# City of Plymouth Planning Commission

## Regular Meeting Agenda

To: Planning Commission  
From: Greta Bolhuis, AICP, Planning and Community Development Director  
Assisted By: Sally Elmiger, AICP, Planning Consultant, Carlisle-Wortman Associates  
Date: June 5, 2026  
Re: Preliminary PUD Review of PUD 26-01: 639 S. Mill, 166 E. Ann Arbor Trail

Date: 10/14/25  
 Scale: 1"=40'  
 Sheet: C-500  
 Project: 20713.00

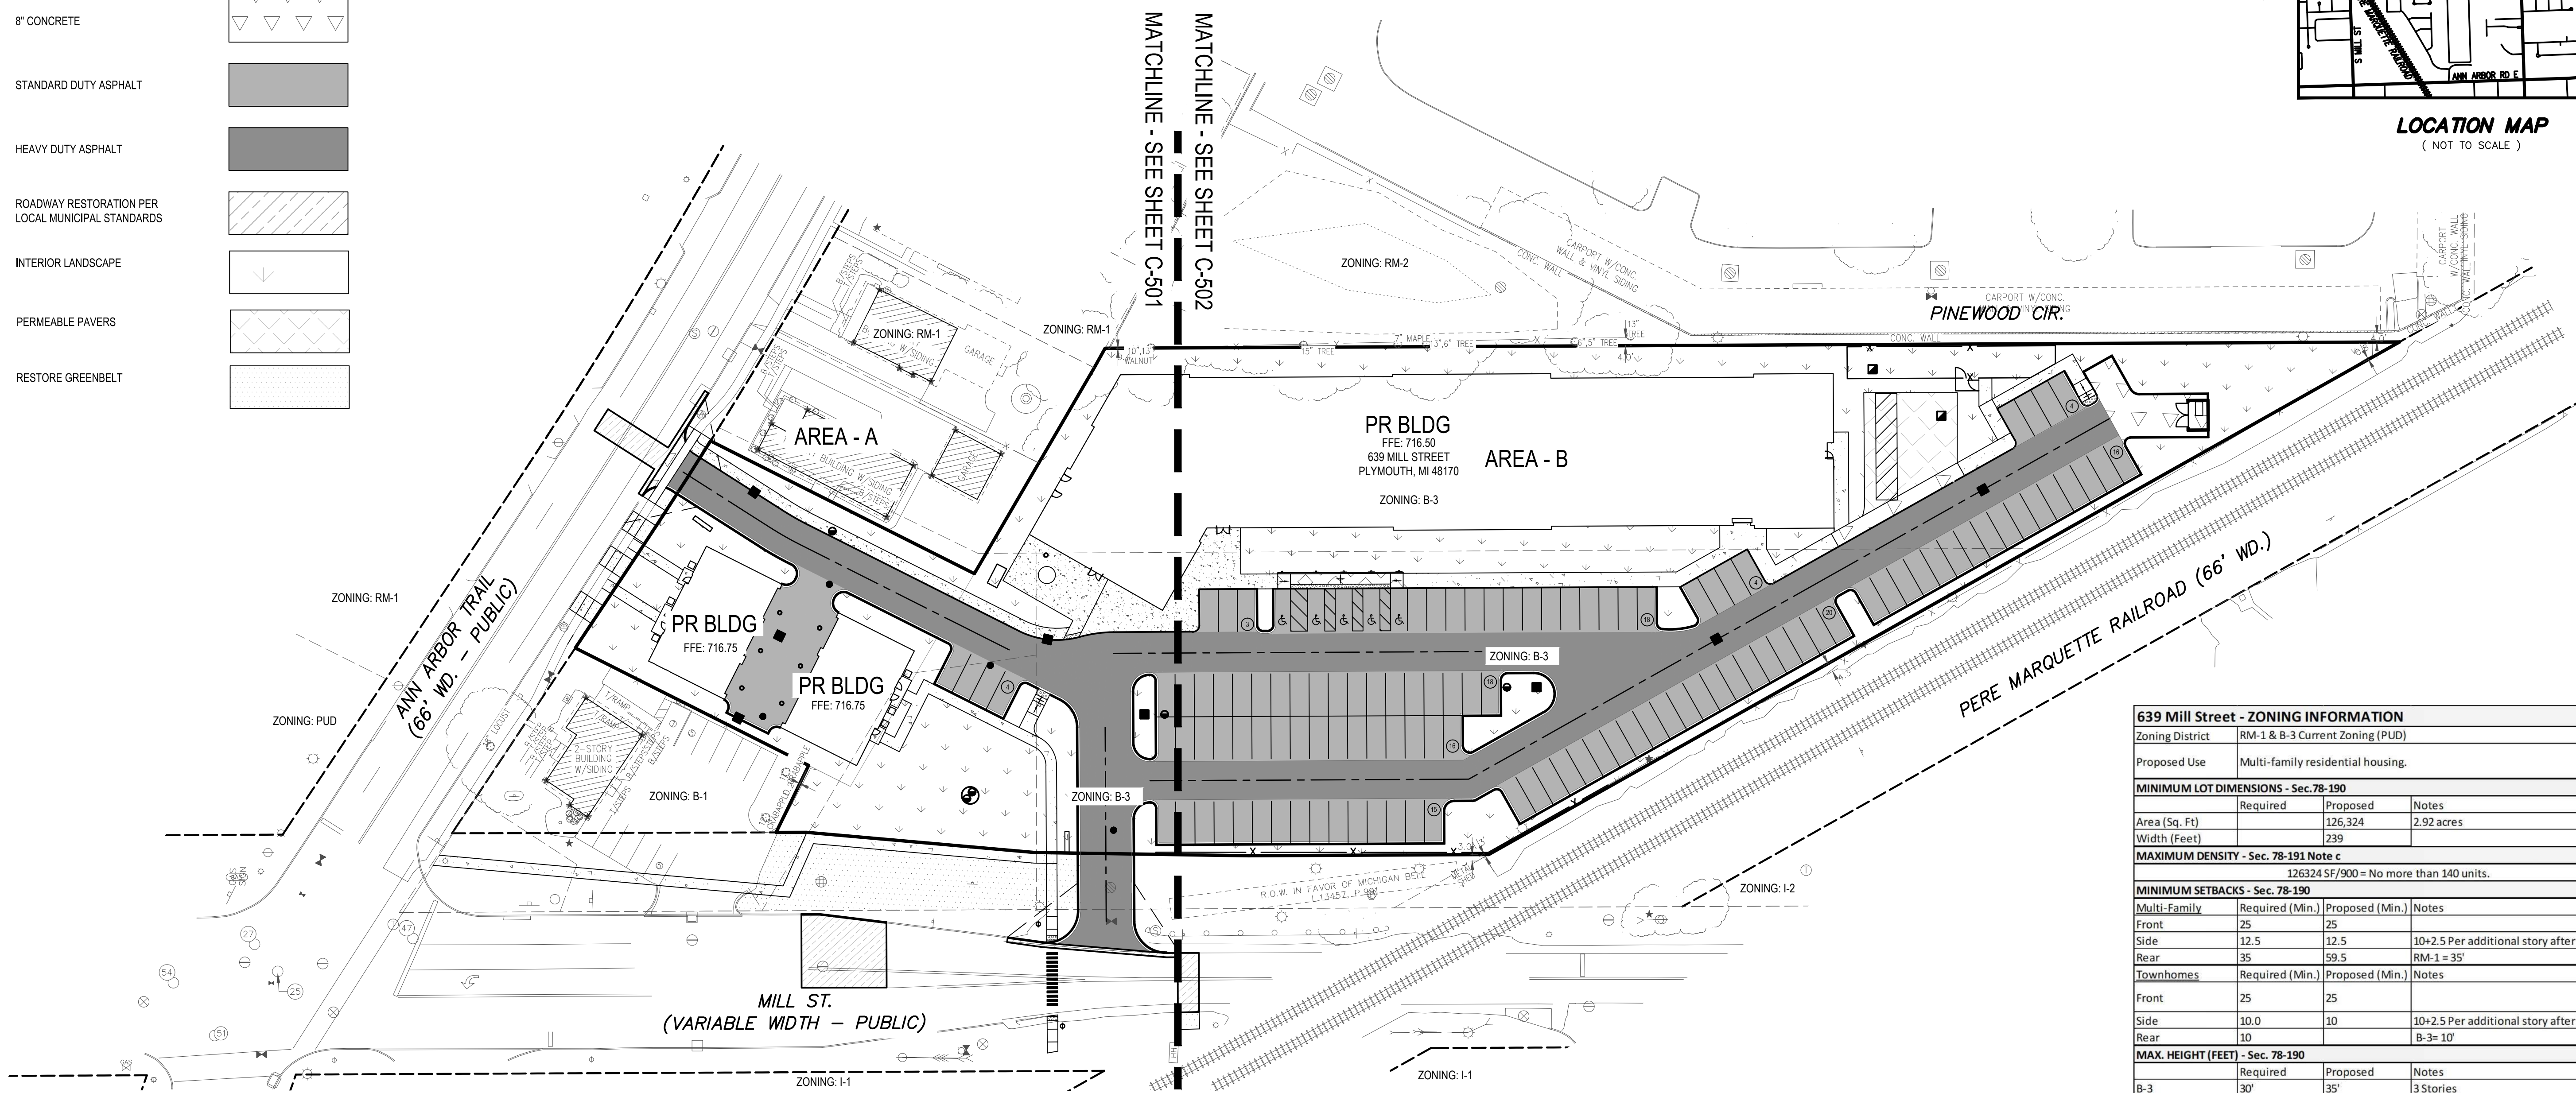
Comments: The plans (Sheet C-501) now show a proposed sidewalk along S. Mill from the intersection of S. Mill and E. Ann Arbor Trail south to the sidewalk entrance to the project. Also shown on the revised plans is a mid-block crossing with rectangular rapid flashing beacons to assist pedestrians in crossing S. Mill on their way to and from downtown Plymouth. Currently, as designed, there are barriers that need to be addressed which are discussed later in this memo.

Date: 10/14/25  
Scale: 1"=40'  
Sheet: C-510  
Project: 20713.00

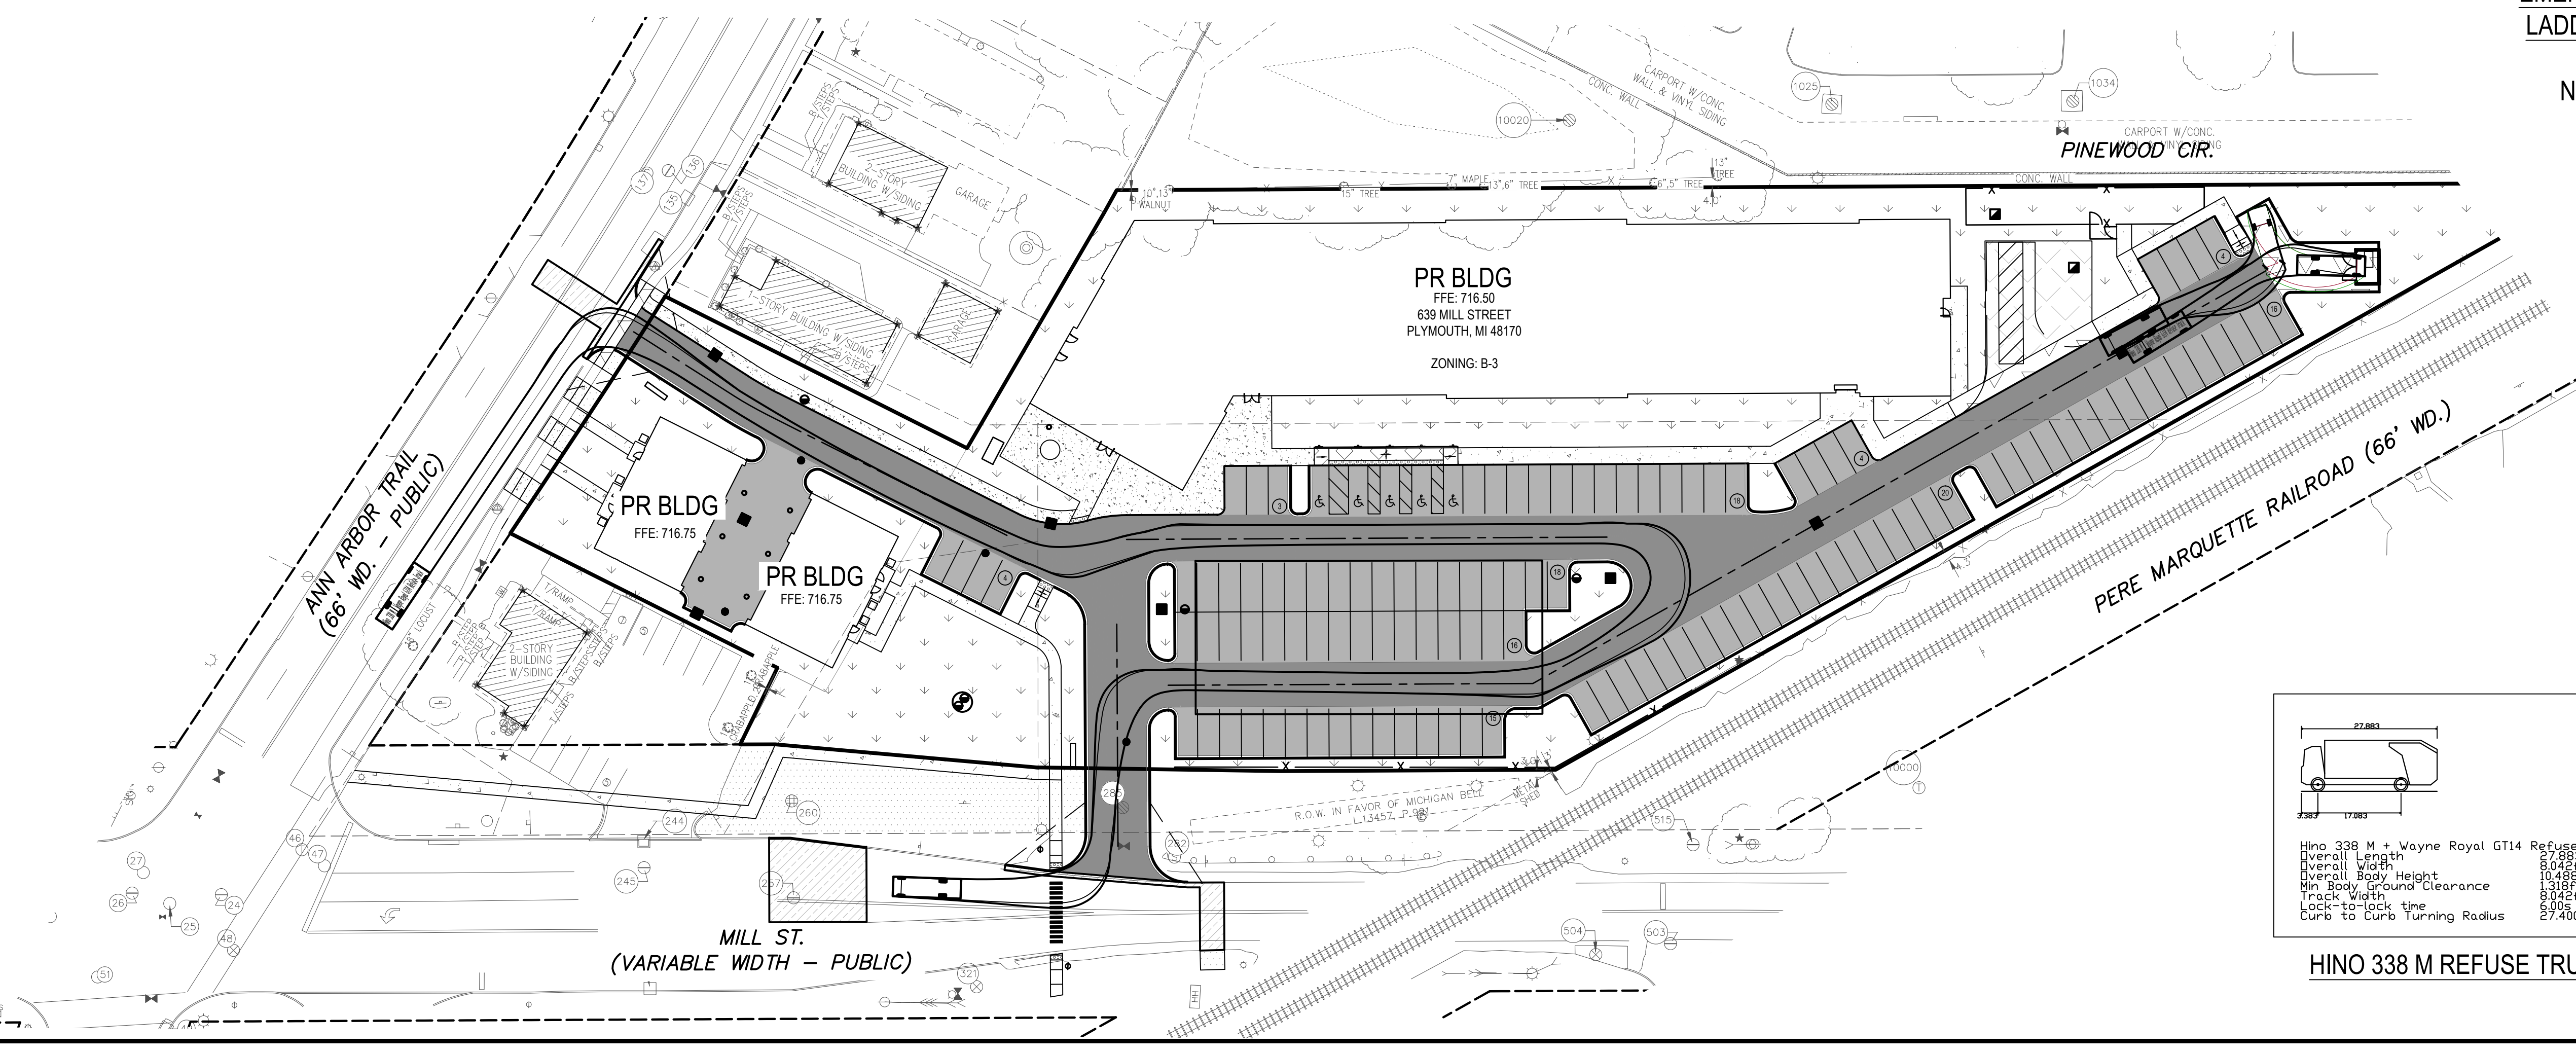
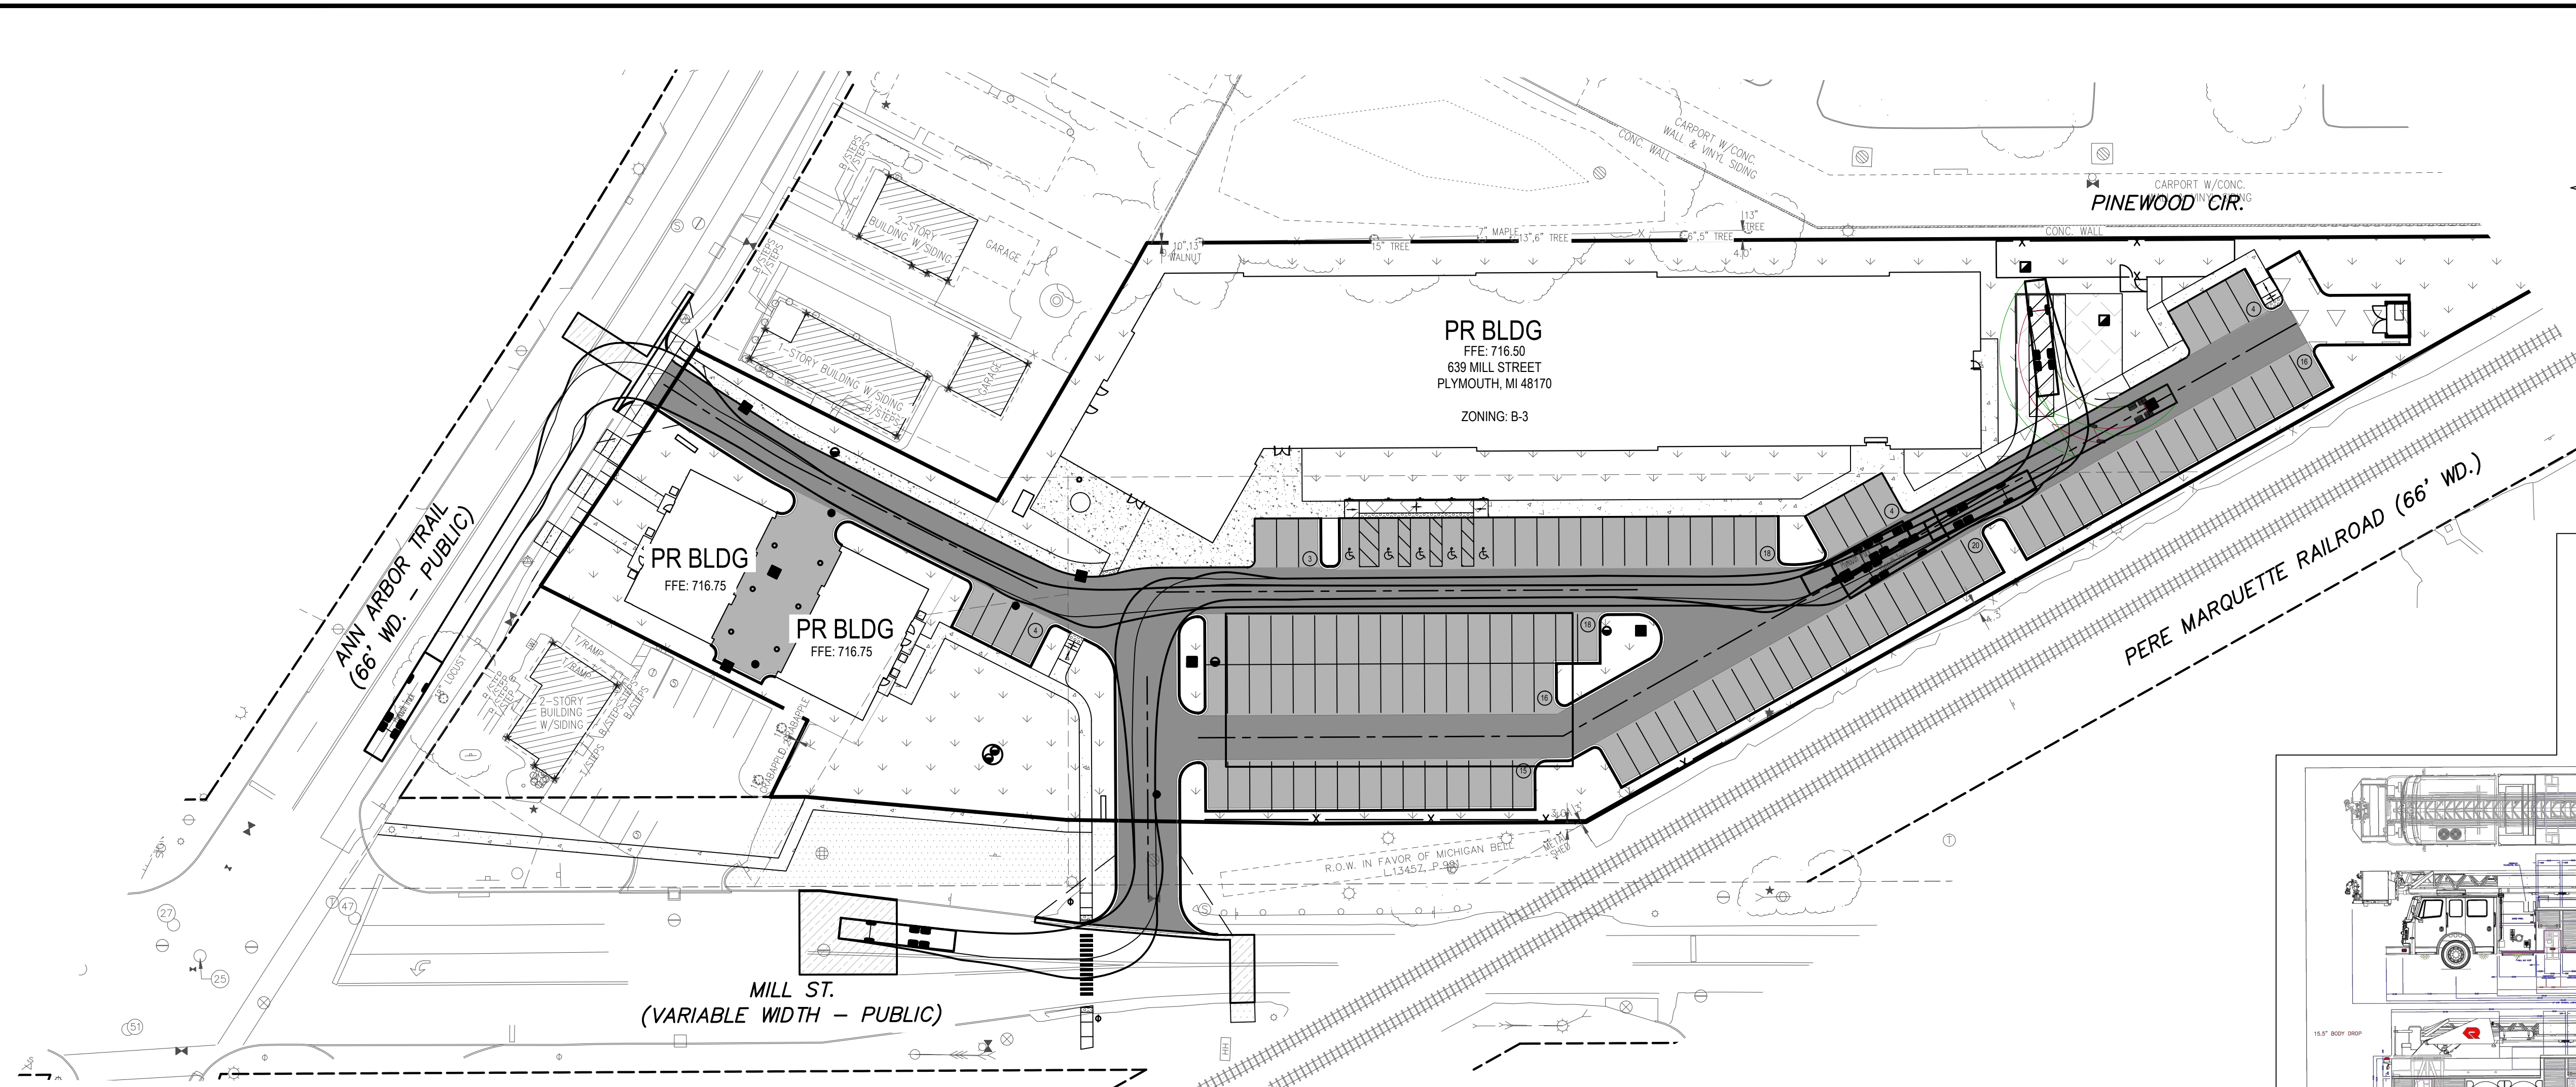
Sheet C-510 shows how a fire truck and garbage truck can traverse the site. The proposal needs to be evaluated by the Fire Chief for emergency access.
